**To:** Jason Boyle, Minnesota Department of Natural Resources (MDNR)  
**Prepared for:** Poly Met Mining, Inc.  
**From:** Tom Radue, P.E.  
**Subject:** Tailings Basin Cell 2E North Dam – Modified Buttress as Alternative to Cement Deep Soil Mix Zone  
**Date:** December 30, 2016  
**c:** Jennifer Saran (PolyMet)

### **Cell 2E North Dam Geometry Modifications and Slope Stability**

Figure 8

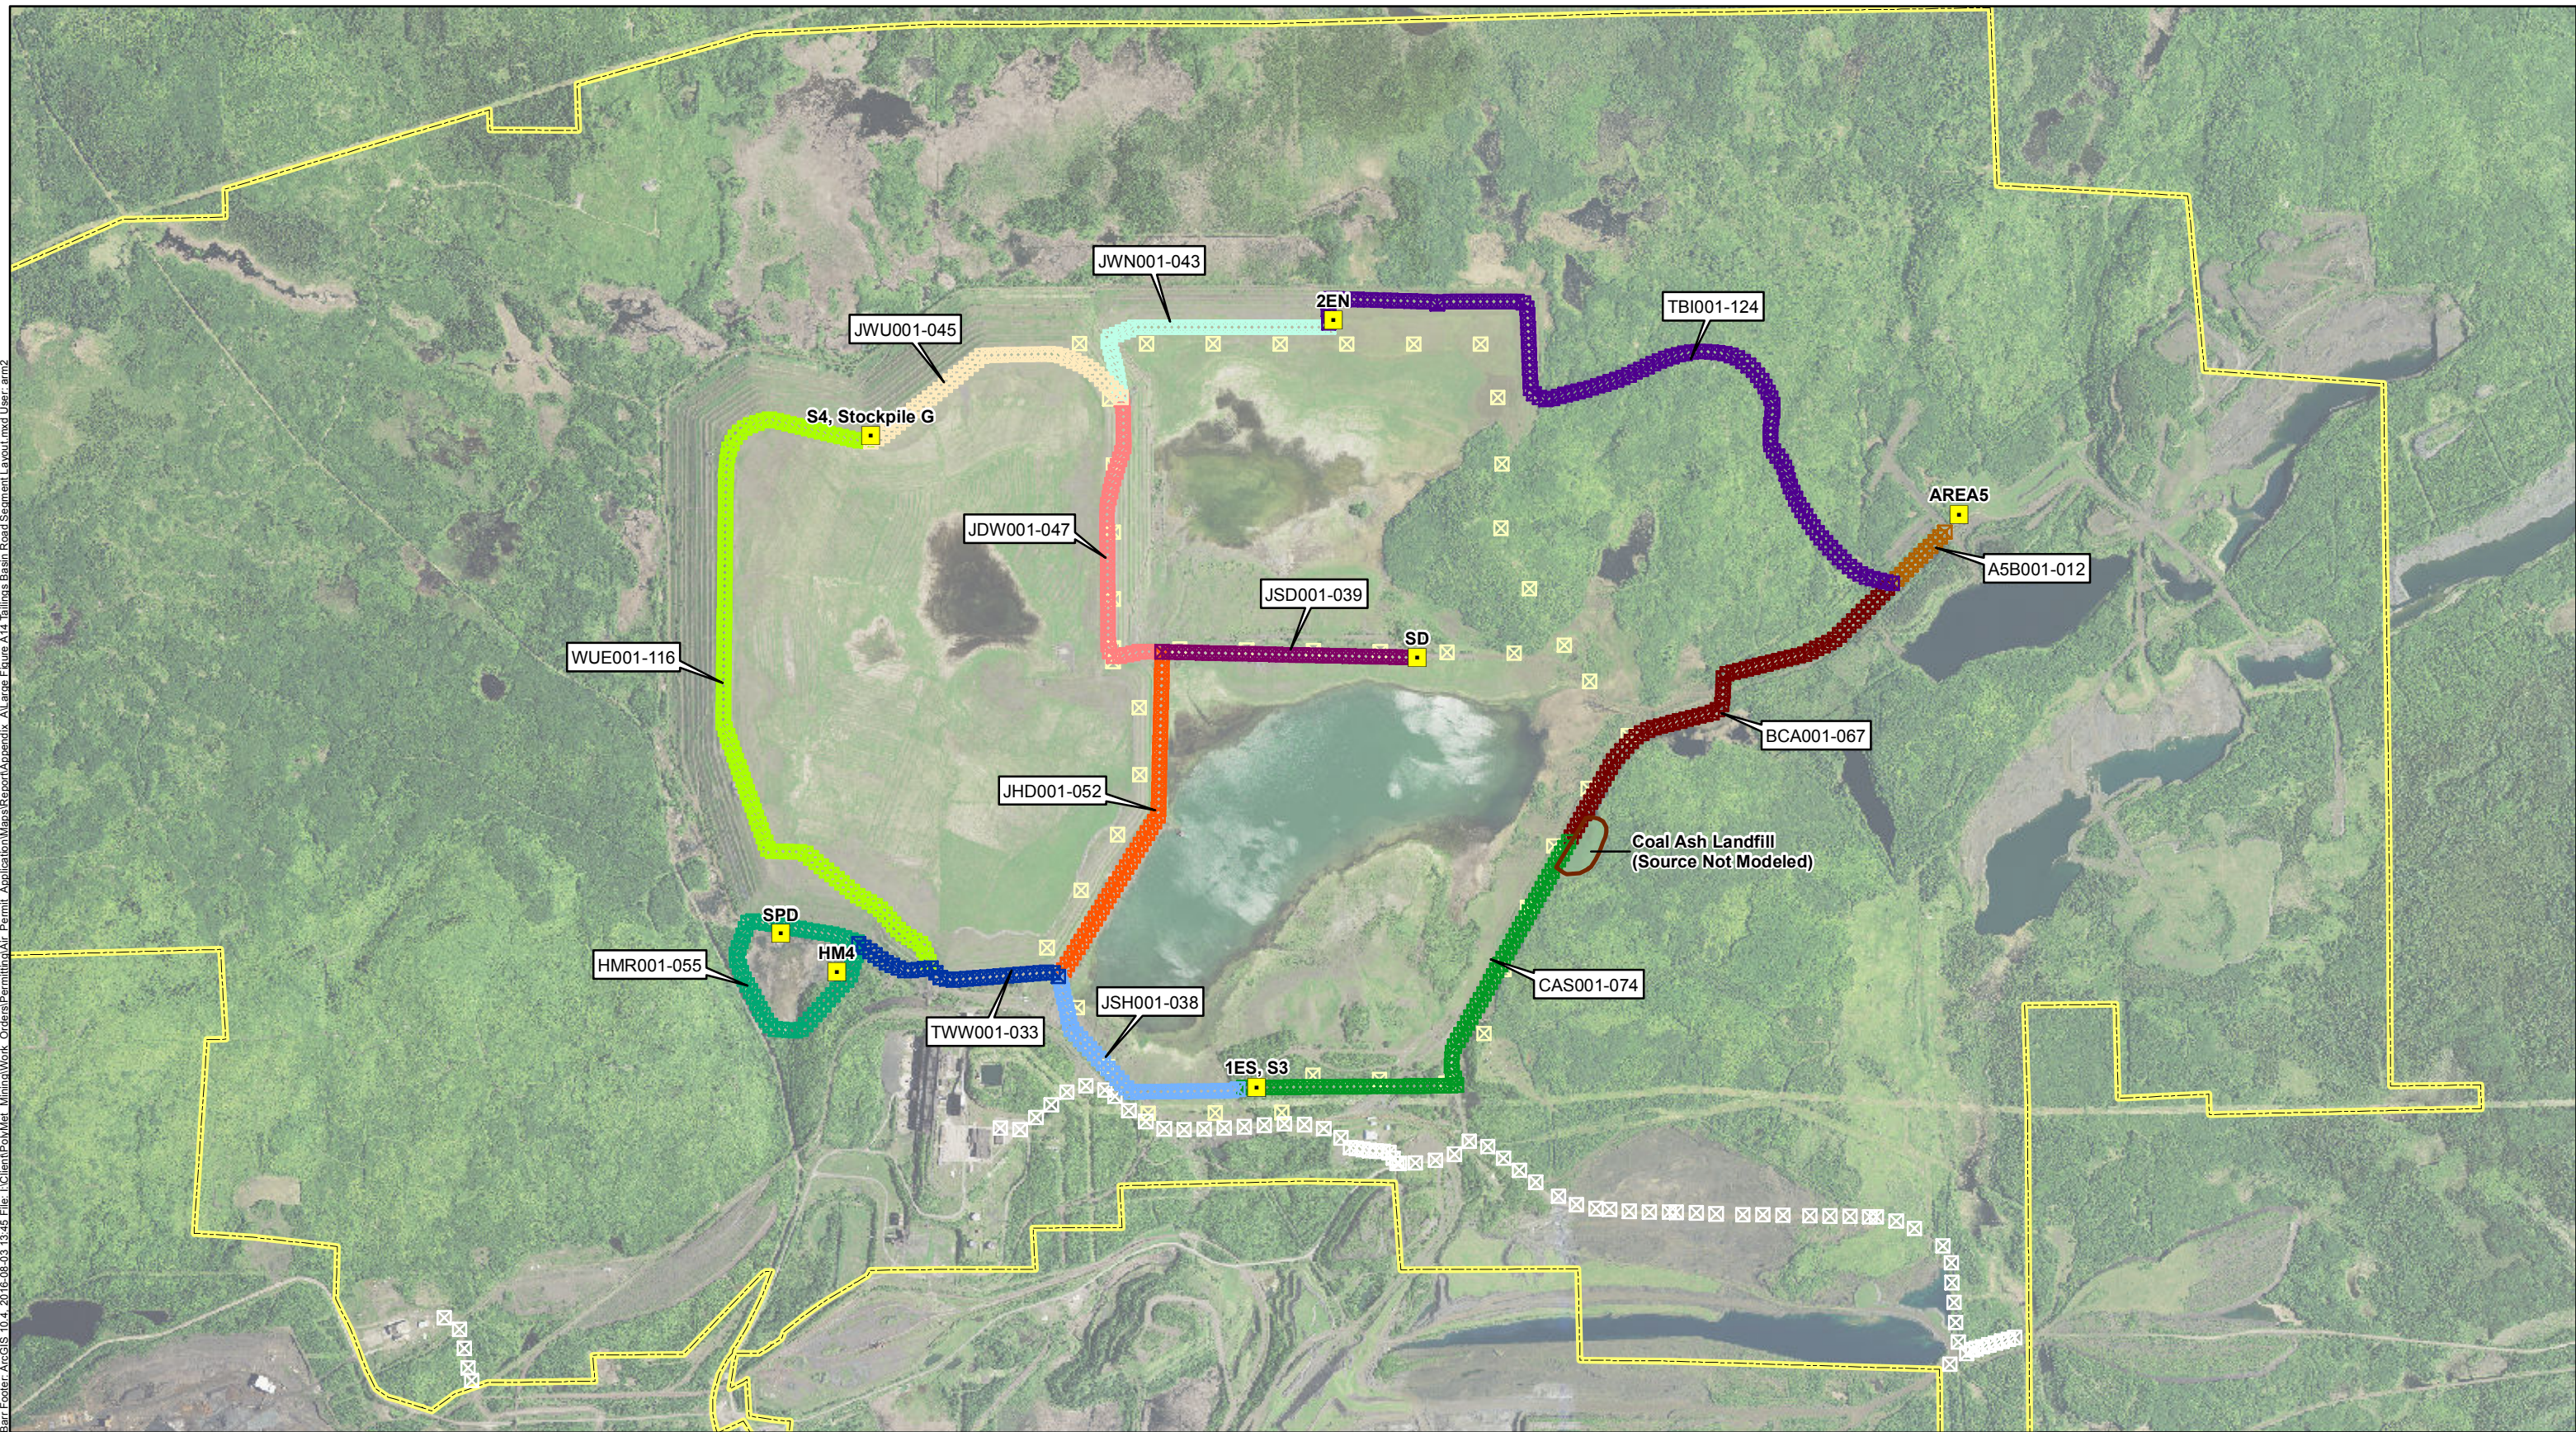
The Tailings Basin construction movement schedule assumes that rock for buttress construction comes from Area 5. The road segments included in the haul route from Area 5 to the north side of Cell 2E are A5B and TBI (Figure 8). Under the revised movement schedule, the maximum trips per hour for A5B and TBI is 32, while under the movement schedule for the previous buttress design the maximum number of trips for both roads is 40. VMT is directly proportional to the number of trips per hour (VMT = trips/hour \* hours/day \* road length \* 2 trips/round trip), so the previously modeled emission rates can accommodate

Buttress construction requires truck loading at the rock source (Area 5 – AREA5 on Figure 8) and unloading at the construction site (near North Dam of Cell 2E – 2EN on Figure 8). Under the proposed revised buttress design movement schedule, the maximum material handling rate at Area 5 goes down from 2398 tons/hour to 1918 tons/hour and the maximum handling rate at the North Dam of Cell 2E goes down from 4194 to 3176.
